DEPARTMENT OF CITY PLANNING

APPEAL REPORT

Case No.: DIR-2020-427-SPP-1A
CEQA No.: ENV-2020-428-CE
Incidental Cases: None
Related Cases: DIR-2020-427-SPP
Council No.: 1-Cedillo
Plan Area: Northeast Los Angeles
Specific Plan: Mount Washington-Glassell Park Specific Plan
Certified NC: Arroyo Seco
GPLU: Low Residential
Zone: R1-1

PROJECT LOCATION: 464 – 466 North Crane Boulevard

SLOPE ANALYSIS MAP

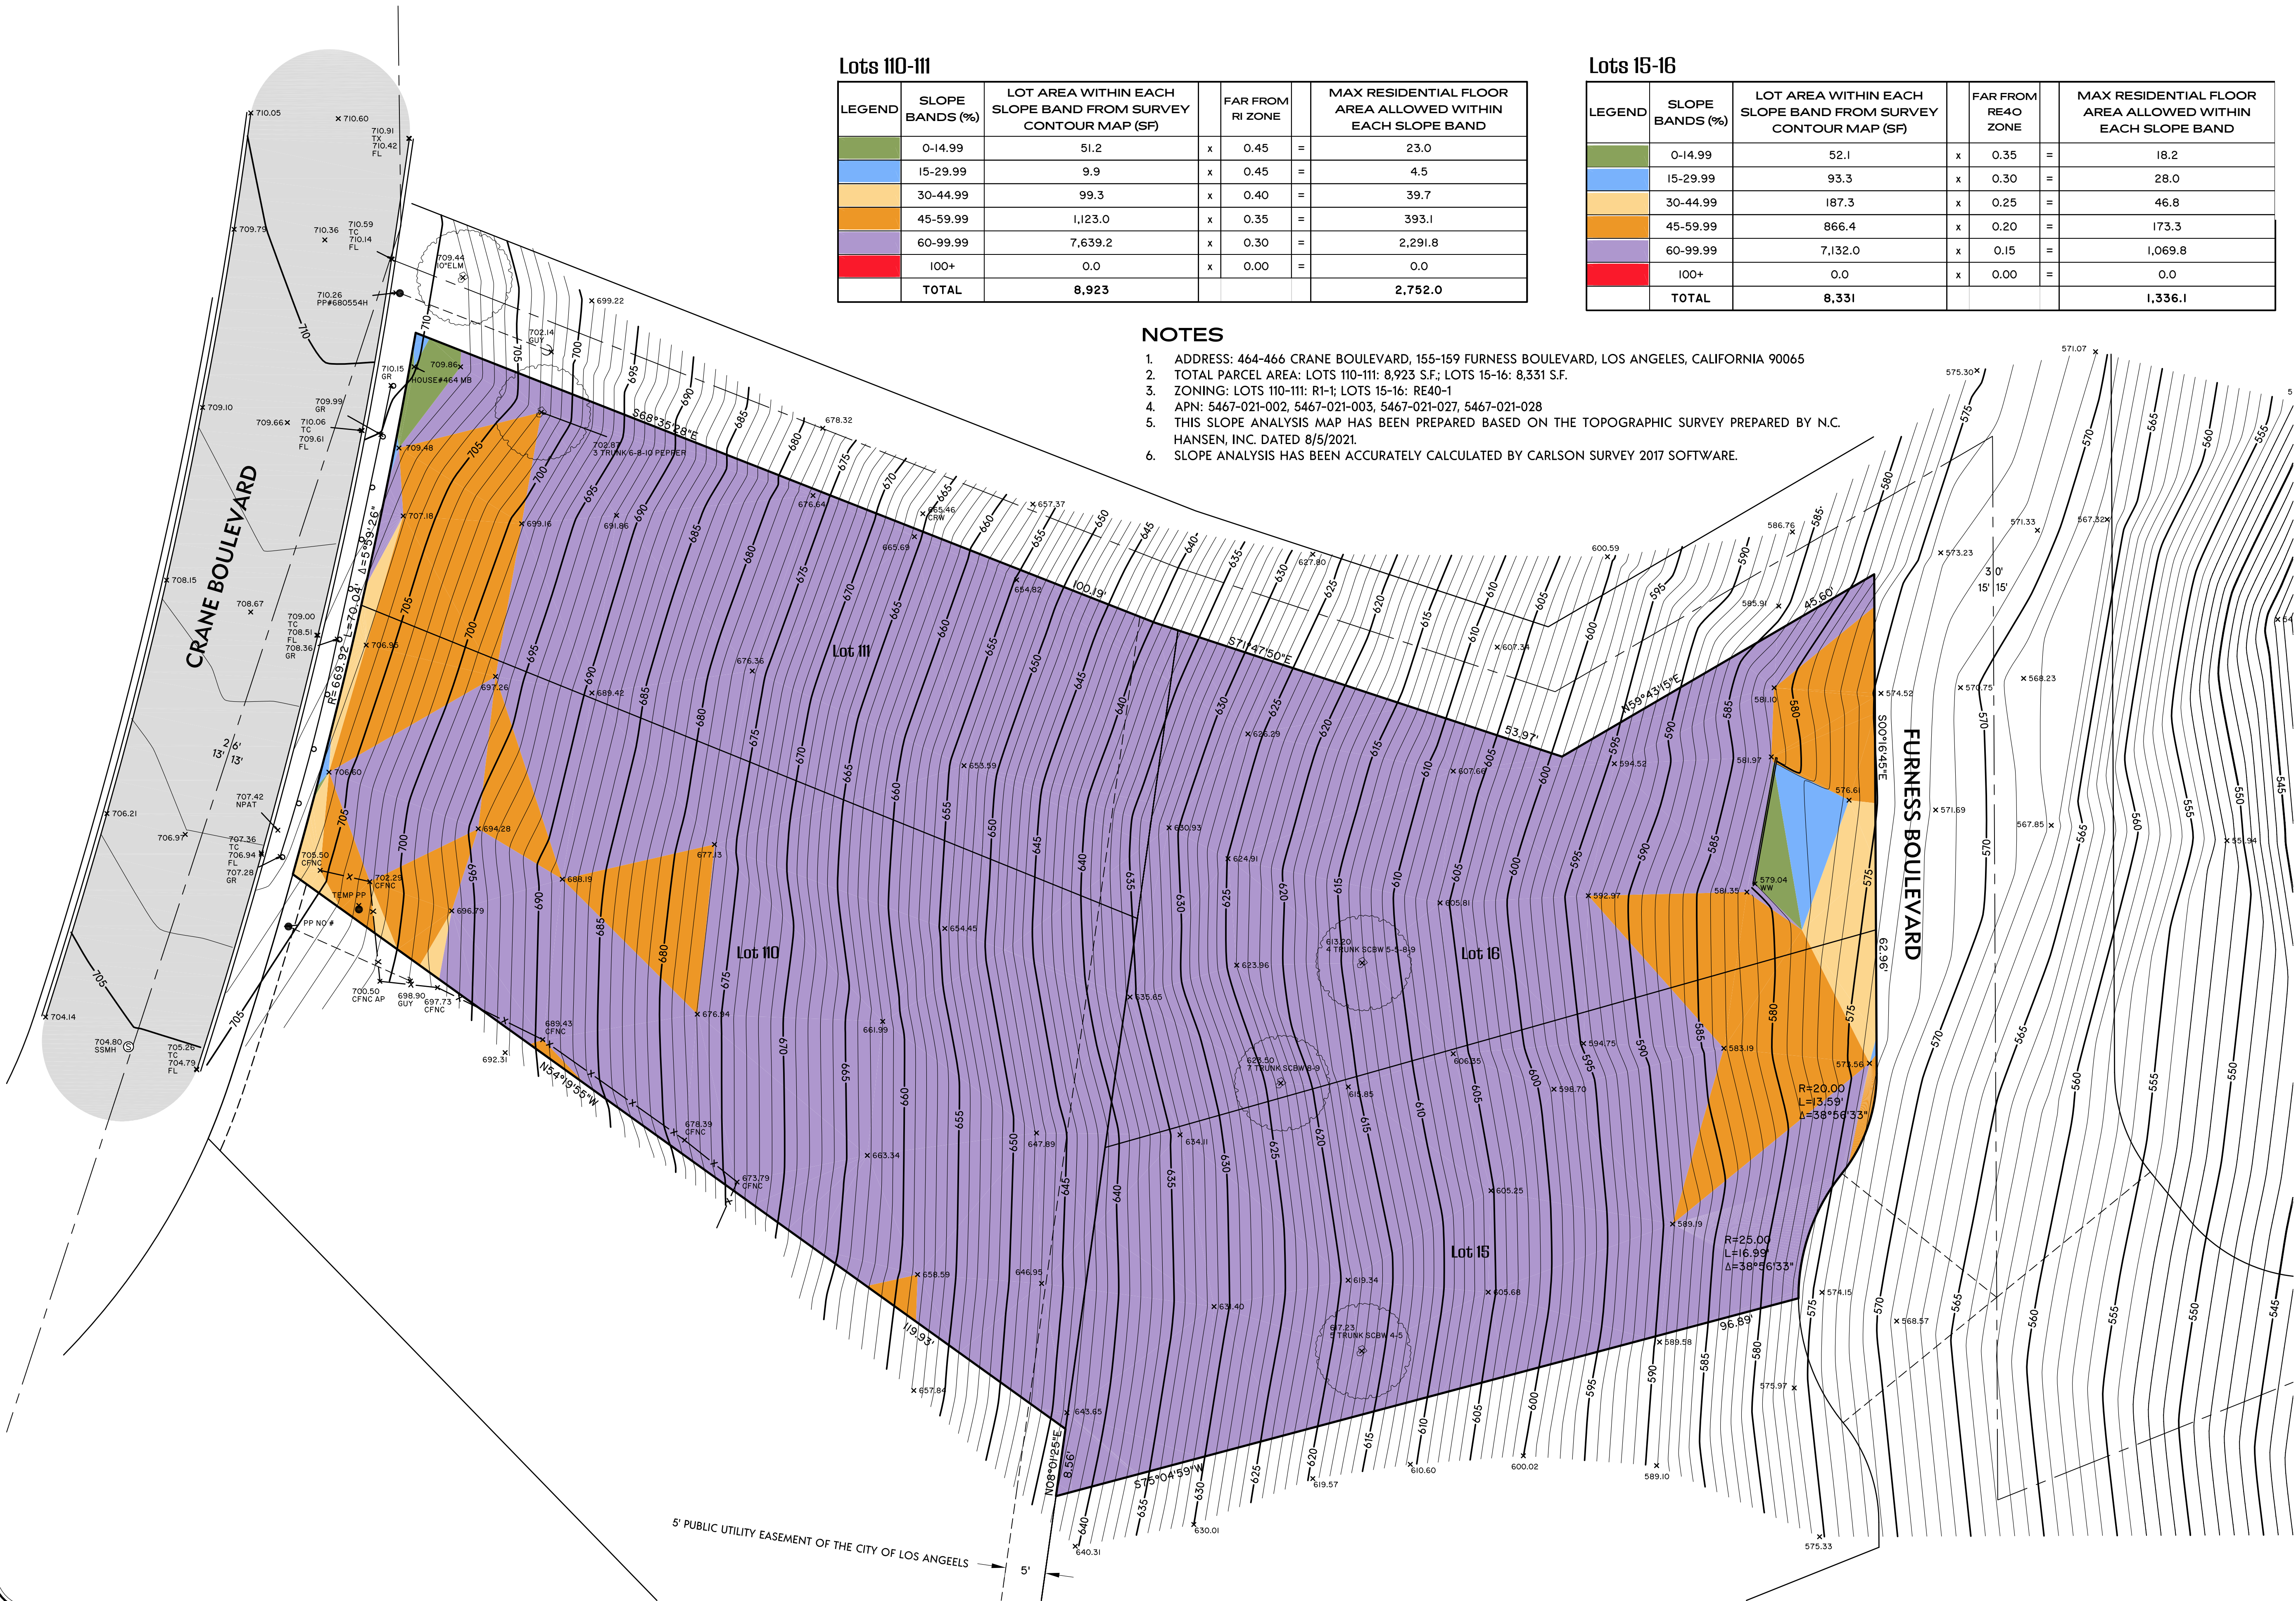
While the slope band analysis in the Baseline Hillside Ordinance may show the allowable square footage that is less than what the Specific Plan provisions would yield, the slope band figure does not truly reflect the total amount of residential floor area that would be allowed on a site. In this instance, the applicant voluntarily prepared a Slope Band Analysis (Exhibit J) showing a maximum residential floor area allowed of 2,752 square feet. The maximum Floor Area for the subject lot using the Specific Plan methodology is 3,743.92 square feet. While at face value the Specific Plan methodology yields a higher

allowable floor area, the Specific Plan methodology is overall more restrictive because the slope band analysis does not show the number of floor area exemptions that would be allowed by the Baseline Hillside Ordinance. For example, the Baseline Hillside Ordinance includes exemptions that allows for fully submerged basements to not count towards the overall residential floor area. The Specific Plan methodology would count those subterranean basement levels toward the overall residential floor area.

Section 2 of the Specific Plan requires the City to apply the most restrictive FAR calculation in either the LAMC or the Specific Plan. Records in Navigate LA show they average slope of the site is at least 65%. Under the Baseline Hillside Ordinance slope band analysis, had it been performed, the City's law would have restricted the size of this project to less than that approved by the City Planners. There has been a grievous abuse in discretion by the Director of Planning refusing to apply the most restrictive FAR calculation because on such a steep lot, the BHO is likely to permit a smaller house to protect public health and safety.

Therefore, because the BHO has the potential to create floor area exemptions that were not intended by the Specific Plan and due to the different methodologies used for calculation floor area, the Department correctly applied the Specific Plan methodology as the more restrictive methodology to approve the proposed project
